Determination 2018/007

Regarding the compliance of door thresholds to a proposed gymnasium in a school at 255 Johns Road, Rangiora

This determination considers the compliance of door thresholds to a proposed gymnasium in a school where the threshold incorporates a change in level of 20mm between the external and internal surfaces. The determination assesses the detail against the Acceptable Solutions D1/AS1, C/AS4 and E2/AS1 and discusses the terms “stepped threshold”, “weather stop” and “isolated step”.

Figure 2: Door threshold detail (not to scale)

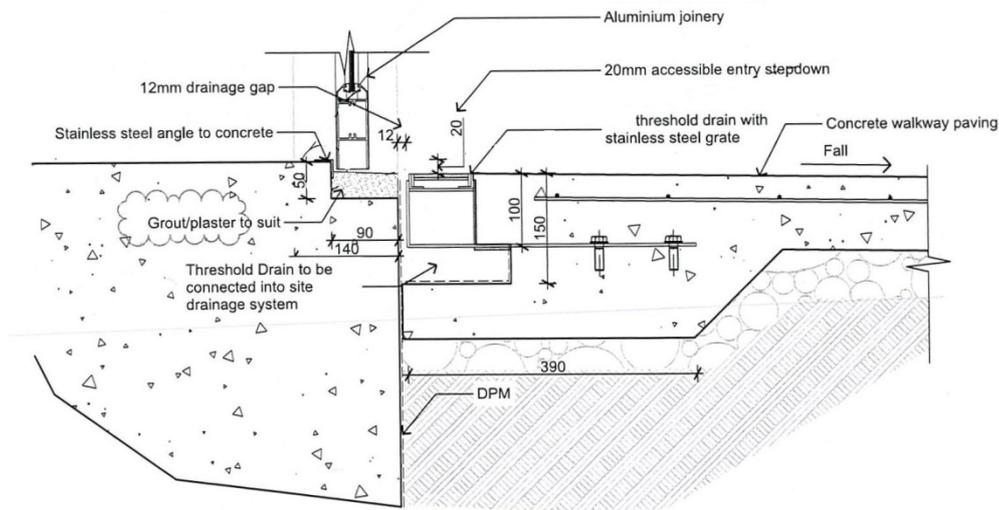
- 3.5 On 3 October 2017 the authority advised the designer that it did not accept the proposed detail (as shown in figure 2); the authority was of the view it does not comply with the Acceptable Solutions or with the Building Code. The authority described an example of a detail that it considered compliant.

- 3.7 The authority responded that it was seeking for the designer to comply with 'the narrative of paragraph 1.3.2 of D1/AS1', and noted that the proposed details 'have a 20mm change in level at the threshold and not a projection above the threshold surface'. The authority noted that the Acceptable Solutions for the C Clauses are consistent with the requirement for the same level on both sides, and referred to Clause 3.15.5(d) and the comment that a 20mm "weather stop" is acceptable. The authority considered the Acceptable Solution allows for a "weather stop" as opposed to a "weather step".

- 3.9 The authority responded to the Ministry on 4 October, maintaining the view it expressed previously, further noting that the Acceptable Solution D1/AS1 at paragraph 1.3.1 states that 'a single isolated step shall not be permitted' and referring also to paragraph 1.3.2 concerning threshold weather stops.

- The proposed detail does not comply with the wording of D1/AS1 paragraphs 1.3.2, 1.3.3 or C/AS4 paragraph 3.15. NZS 4121/ D1/AS1 and C/AS4 act together to require level access routes.

- 6.3.7 In its submissions, the authority has expressed the view that the disputed detail does not constitute a weather stop. In the authority’s opinion, a weather stop ‘must form part of the doorsill, not the external surface’. The authority also states that a threshold on the other hand is as defined in D1/AS1, and is a ‘sill to an external door, or the floor under an internal door’. The authority’s argument is that the 20mm change in level does not constitute a weather stop for the purposes of paragraph 1.3.2, but is an isolated step, which is prohibited in Clause D1.3.1(i) of the Building

- 6.3.11 D1/AS1 provides for the use of a weather stop provided that it is no more than 20mm. I conclude that the design detail shown in Figure 2 constitutes a weather stop in terms of Acceptable Solution D1/AS1 and therefore is deemed to comply with Clause D1 of the Building Code.

6.4.2 As I have concluded that the design detail complies with D1/AS1, it follows that as the doors are external doors the detail also complies with C/AS4.

6.5.4 Taking into account the discussion in paragraph 6.3 above with regard to stepped thresholds and weather stops, I conclude that the proposed detail is of an equivalent nature to the design shown in Figure 17B, and that as a result it also complies with Clause E2/AS1 with regard to the 20mm change in level.

7.1 In accordance with section 188 of the Building Act 2004, I hereby determine that the proposed access to the gymnasium as shown in Figure 2 of this determination complies with D1/AS1, C/AS4, and E2/AS1, and is therefore deemed to comply with the Building Code.

Figure 3:

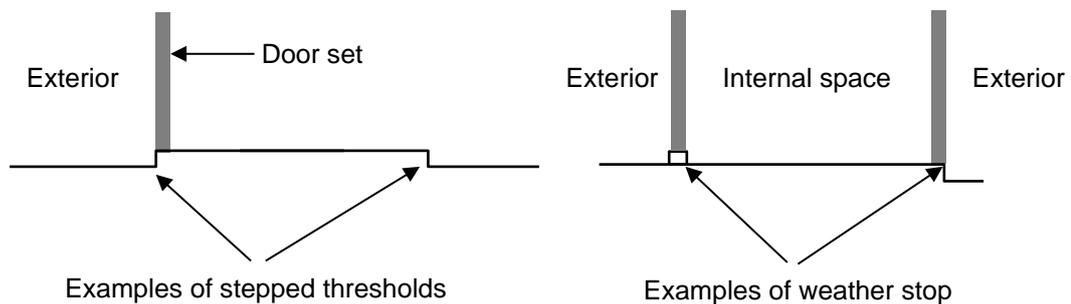
- 6.3.8 In general terms, and as described in the sketch in Figure 3 below, I consider that a “stepped threshold” constitutes a change in level where one side of a threshold is higher than the other – it does not necessarily need to be an external threshold nor incorporate a doorset, it may simply be a transition from one space to another where there is a change of level. I consider a “weather stop” to be a building element that is raised in height above the level of the exterior surface for the purpose of keeping external moisture from entering the building. Weather stops are often incorporated into the design of doorsets and therefore project above adjacent surfaces.

- 6.3.9 D1/AS1 uses two different terms “isolated step” and “weather stop”. The term “isolated step” is used in D1/AS1 to describe a change of level. The term “weather stop” is used in D1/AS1 only in relation external doors. I am of the view that while a weather stop is often incorporated into a doorset, the Acceptable Solution does not preclude the use of a “stepped threshold” from being incorporated in the design of a weather stop.

Figure 17B: Level thresholds for ground level
Paragraph 7.3 and Figure 17A

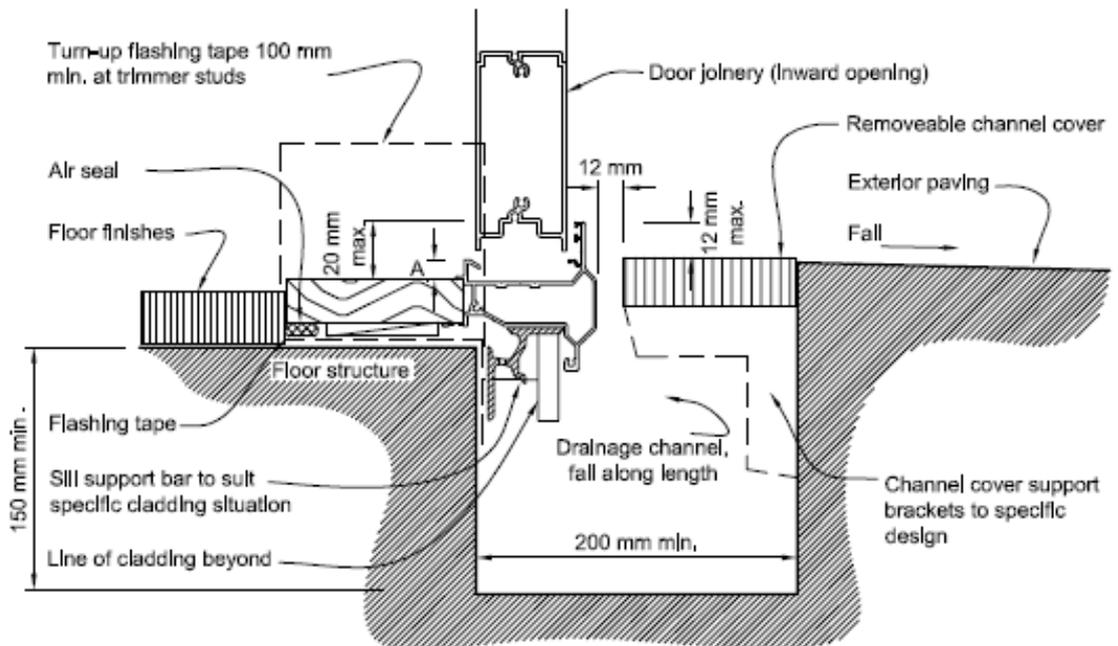
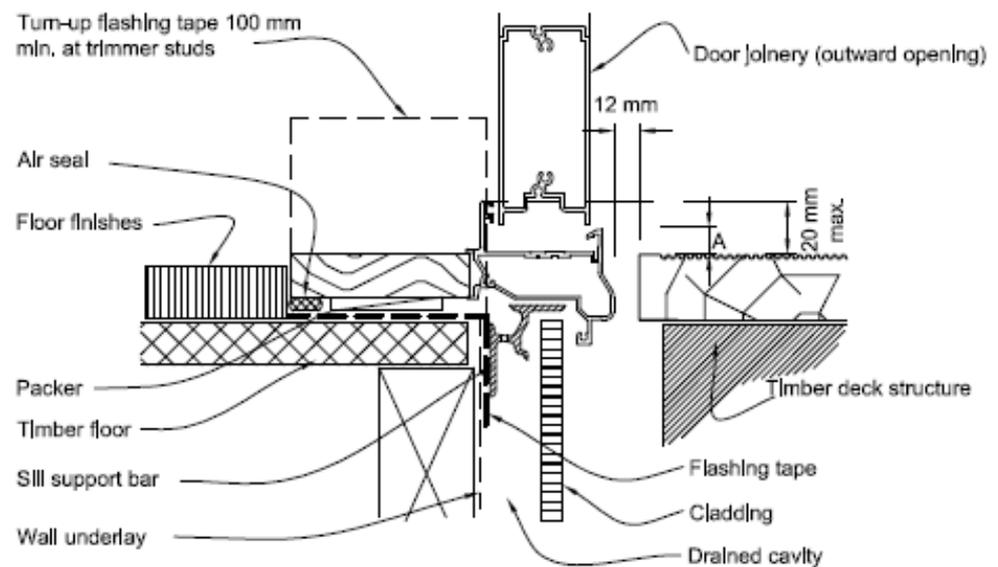
6.5.3 In the Acceptable Solution, figure 17B (a) concrete slab, and (b) timber floor both show a doorset that incorporates a 20mm projection, so while the internal and external levels are the same there is still a 20mm height present at the threshold.
